REMARKS

Claims 1 and 5 have been amended. Claims 6-11 and 41-53 have been cancelled.

FIG. 21 (PRIOR ART)

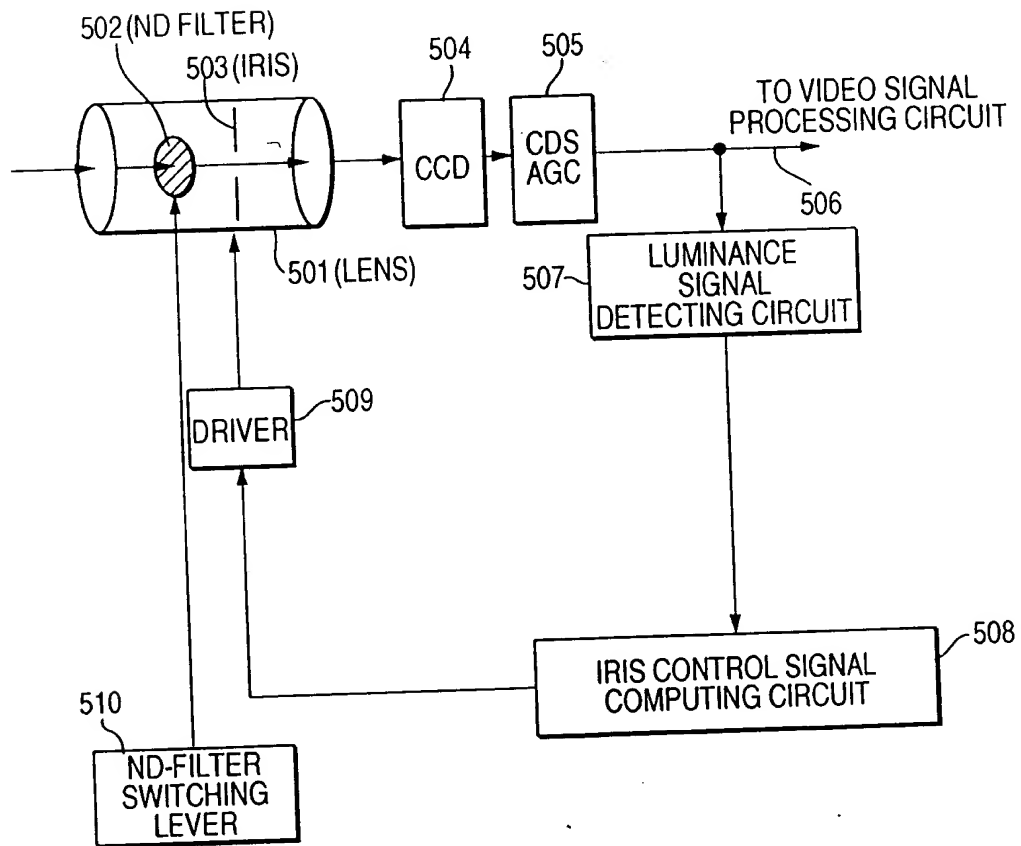
Legend Added

The Examiner has objected to applicant's drawings because in FIGS. 21-28(c) only that which is old is illustrated and FIGS. 21-28(c) should be designated by a legend such as -- Prior Art --. Applicant has amended applicant's FIGS. 21-28(c) to add a legend "Prior Art" to each figure as suggested by the Examiner, thereby obviating the Examiner's objection.

FIG. 23 (PRIOR ART)

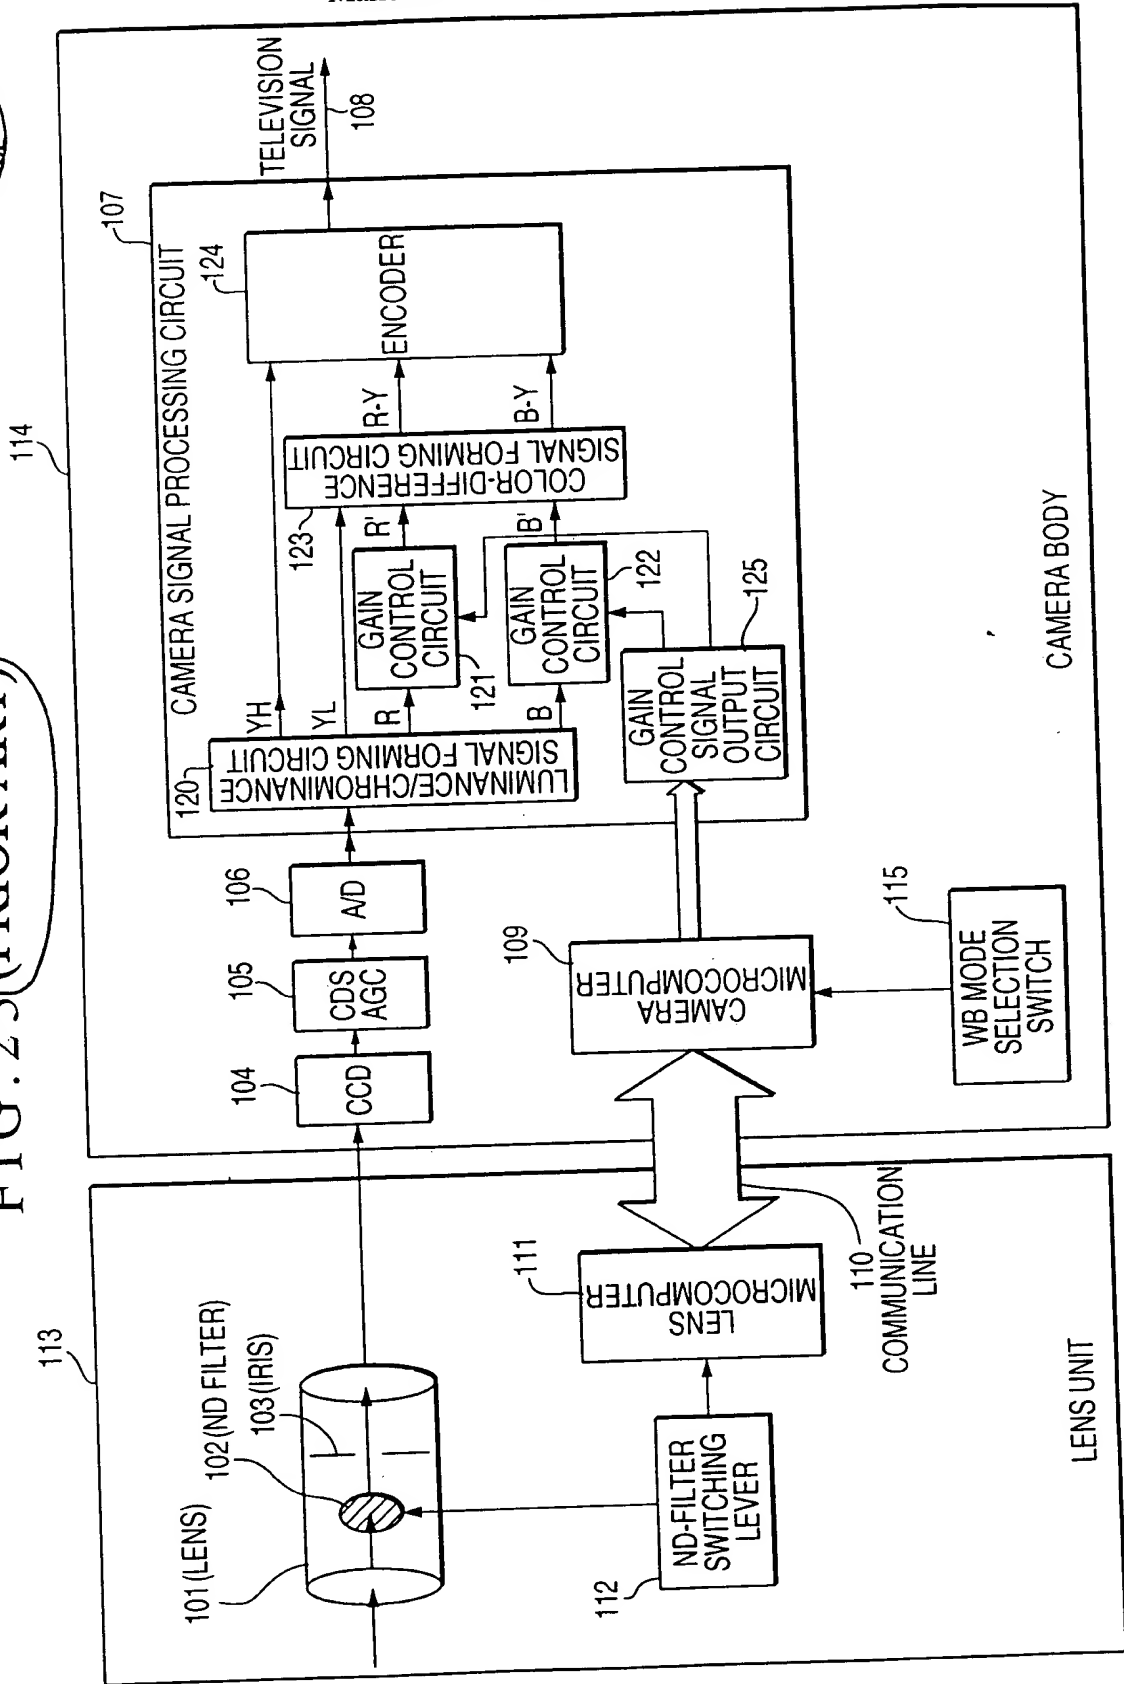
Legend Added

FIG. 26(a)

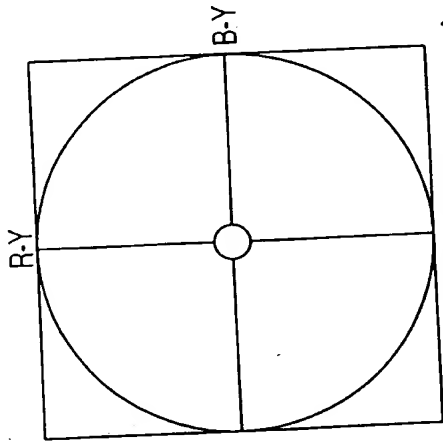
Legend Added

FIG. 26(c)

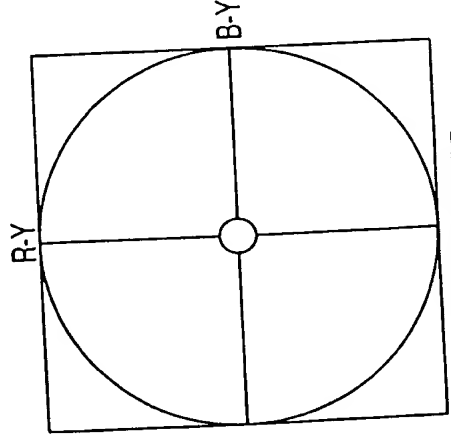
Legend Added

FIG. 26(b)

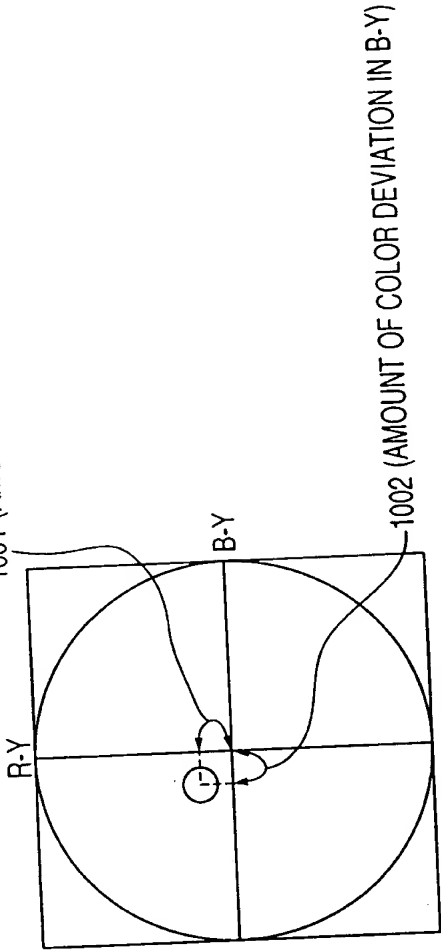
Legend Added

FIG. 26(d)

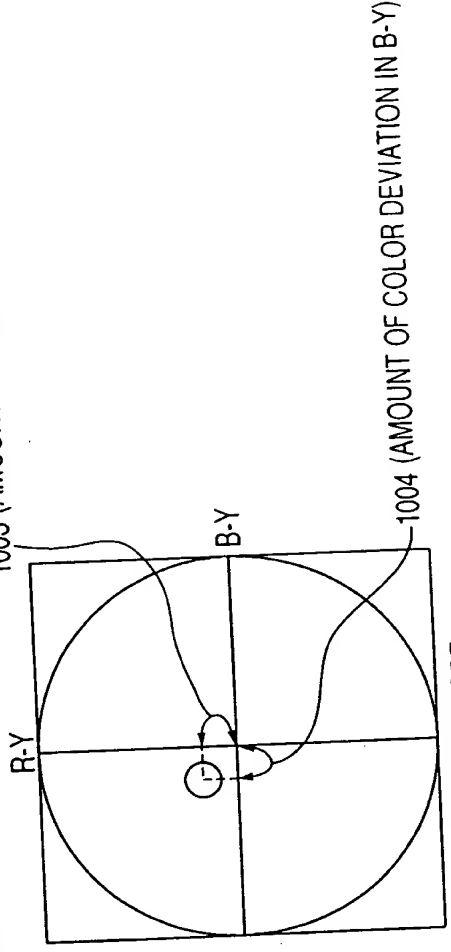
Legend Added

FIG. 27 (PRIOR ART)

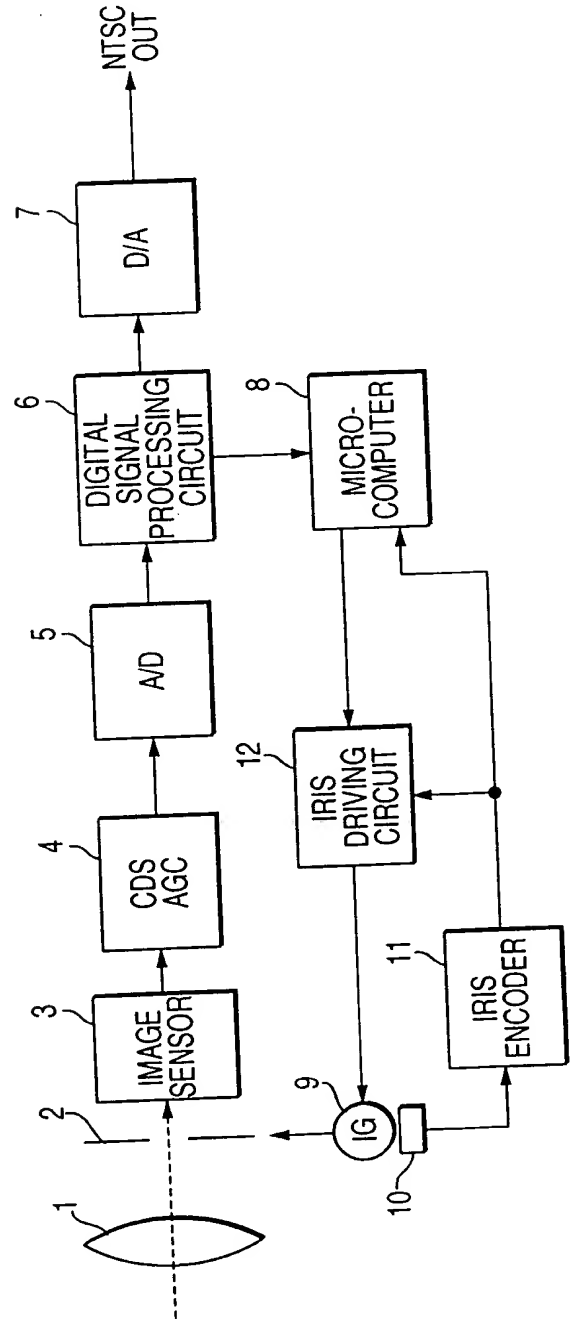
Legend Added
